Staff Presentation to the ACRS Sub-Committee

NuScale Licensing Topical Report

Methodology for Establishing the Technical Basis for Plume Exposure Emergency Planning Zones at NuScale Small Modular Reactor Plant Sites (TR-0915-17772, Revision 3)

SEPTEMBER 8, 2022

Seismic Risk – Potential Dominant Contributor for the NuScale Design

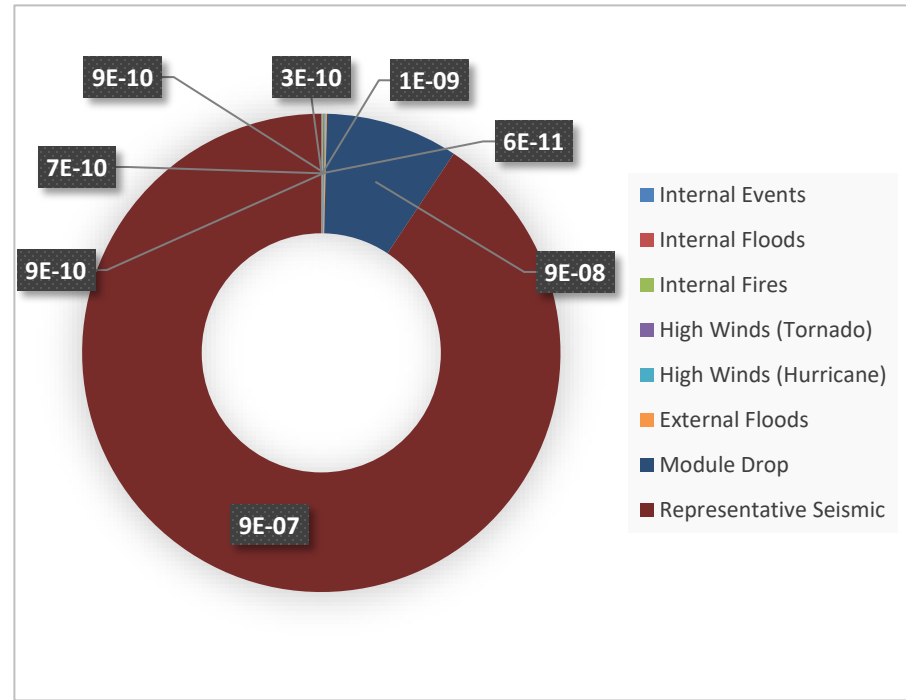
- Purpose of EPZ is dose savings and not dose avoidance
 - NUREG 0396: “...while the EPZ should not be solely dependent on the most severe and most improbable BDBEs, the determination of the EPZ size needs to include some of the key characteristics of very large releases.”
- Seismic risk expected to dominate NuScale risk profile and EPZ sizing
 - Design reduces the risk from internal events
 - Timing of seismically-initiated sequences different compared to non-seismic events
 - Inclusion in spectrum of accidents maintains consistency with NUREG-0396

Figure 1 in NRC staff's safety evaluation (ML22118A760)

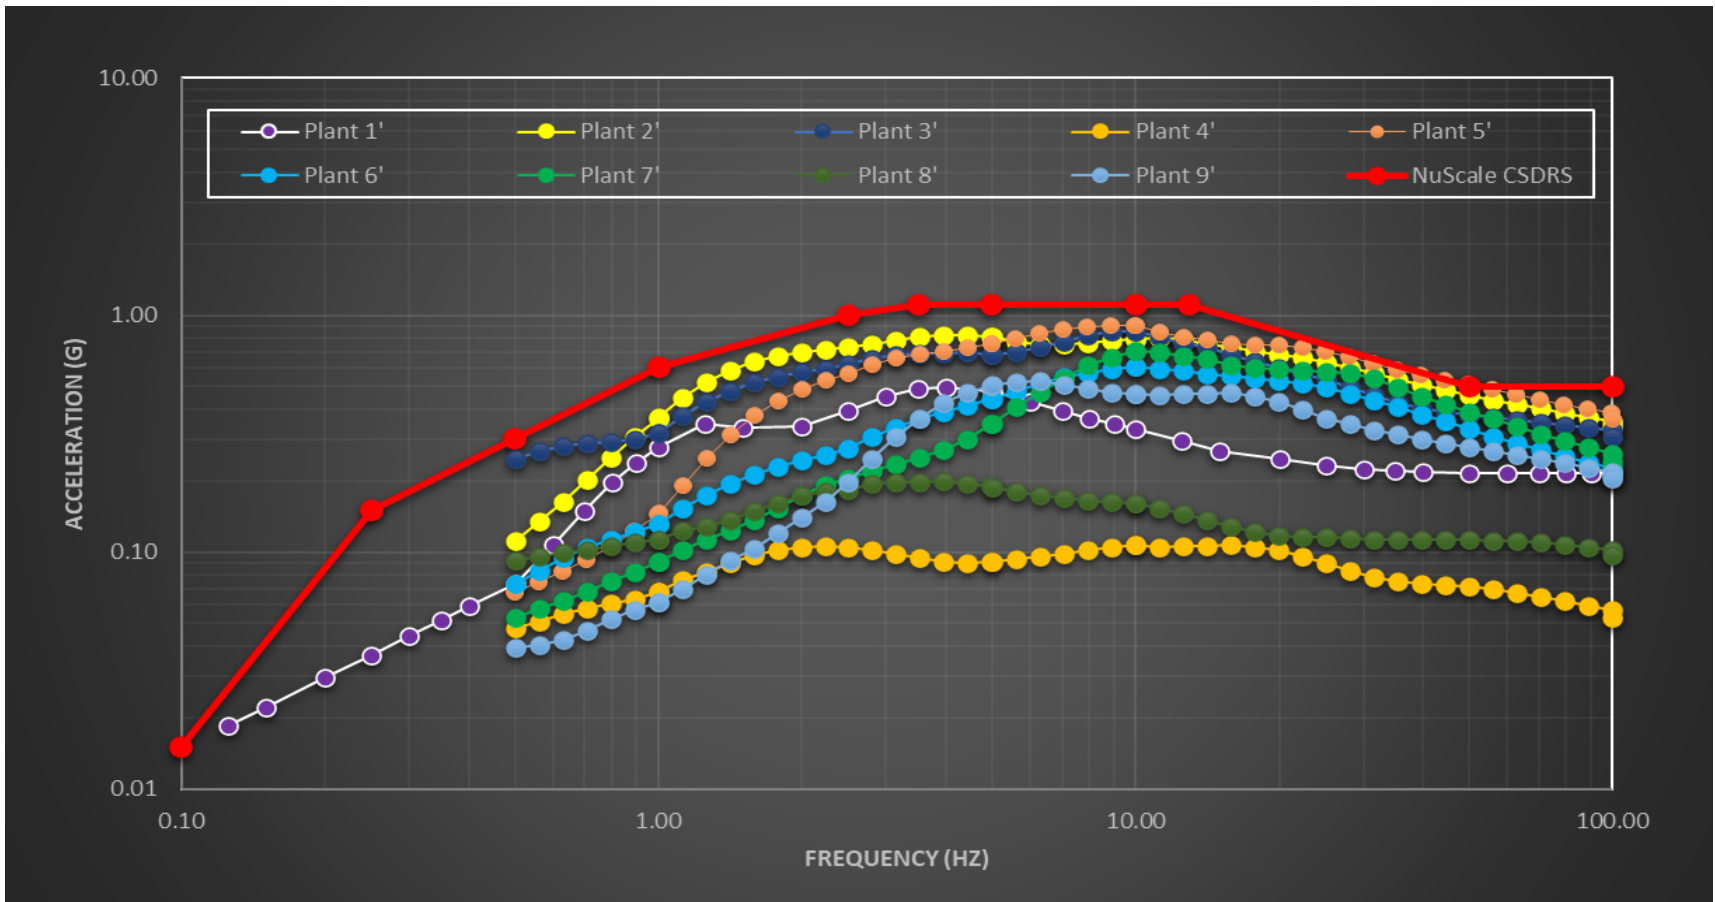
- Staff evaluation used “risk gap” approach with 9 operating reactor sites
 - Within NuScale Certified Seismic Design Response Spectra
 - Using NuScale high confidence of low probability of failure (HCLPF) plant-level fragility
 - Threshold captures 20% – 50% of seismic risk for the NuScale design across majority of 9 sites

- Achieves consistency with NUREG-0396 and WASH-1400 for seismic events
 - Results in a complete spectrum of accidents
 - Avoids extremely unlikely seismic accelerations
 - Does not ‘penalize’ NuScale for its risk profile
- Addresses multi-module risk (details in subsequent slide)
- Uses quantified seismic sequences because they can be dominant contributor to plant risk and EPZ sizing
